Item Name: AS350/AS355 Quick Release Heli-Utility-Basket™ Long, Heavy Duty Lid

Work Order ID 159795

DART SERVICE INSTRUCTION

**TO AMEND INSTALLATION INSTRUCTIONS D350-607-3 Rev.D,
INSTALLATION INSTRUCTIONS D350-607-4 Rev. C AND
INSTRUCTIONS FOR CONTINUED AIRWORTHINESS ICA-D350-607 REV. 6**

FIGURE 1: INSTALLATION OF D4775-041 FWD STRUT

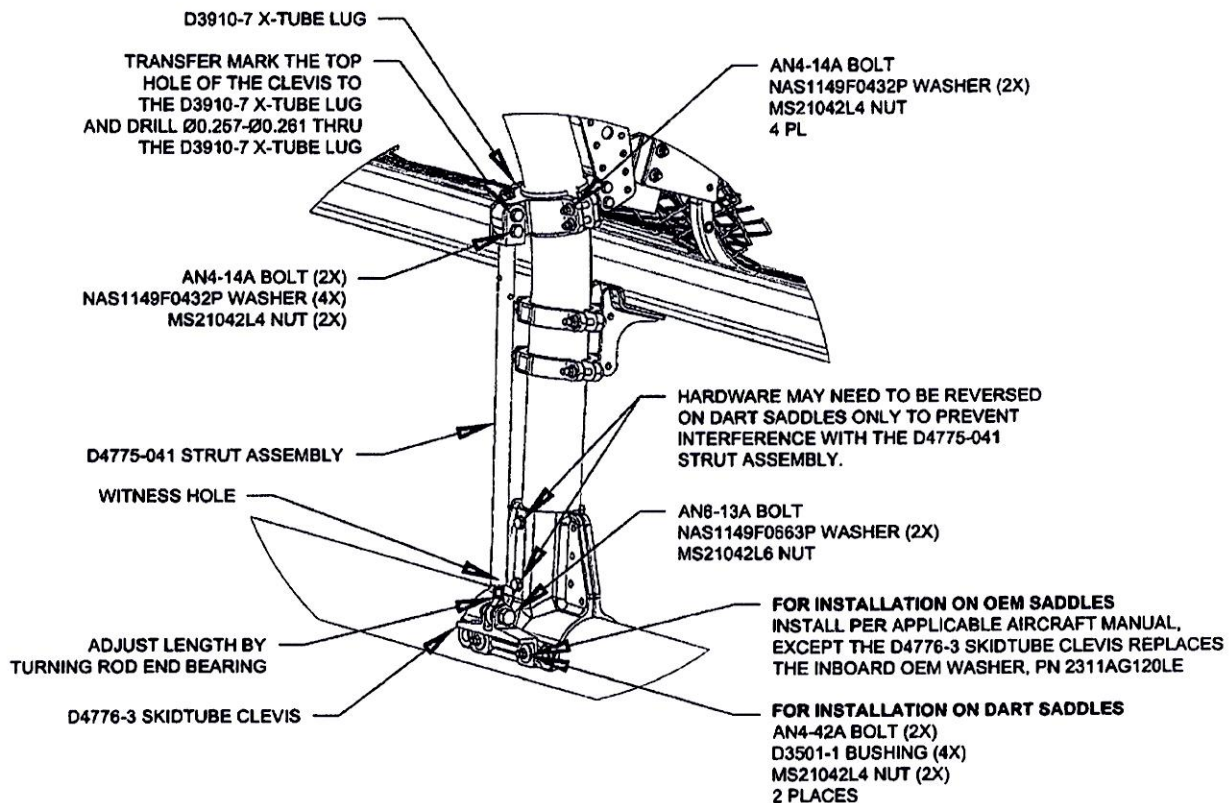
3.1 Substitute the Forward Lower D3910-5 X-Tube Lug with the D3910-7 X-Tube Lug as shown in Figure 1.

3.2 Install the forward D4775-041 Strut Assembly. Transfer mark from the upper hole on the clevis of the D4775-041 Strut Assembly to the D3910-7 X-tube Lug and drill thru the lug $\varnothing 0.257$ - $\varnothing 0.261$ as shown in Figure 1. Touch up chemical conversion coating per MIL-DTL-5541. Check the witness holes located at the bottom end of the D4775-041 Strut Assemblies to ensure that the thread from the rod end extends past the witness hole.
Torque MS21042L4/-4 nuts to 50-70 in-lbs (5.7-7.9 N-m). Torque MS21042L6/-6 nuts to 160-190 in-lbs (18.1-21.5 N-m).
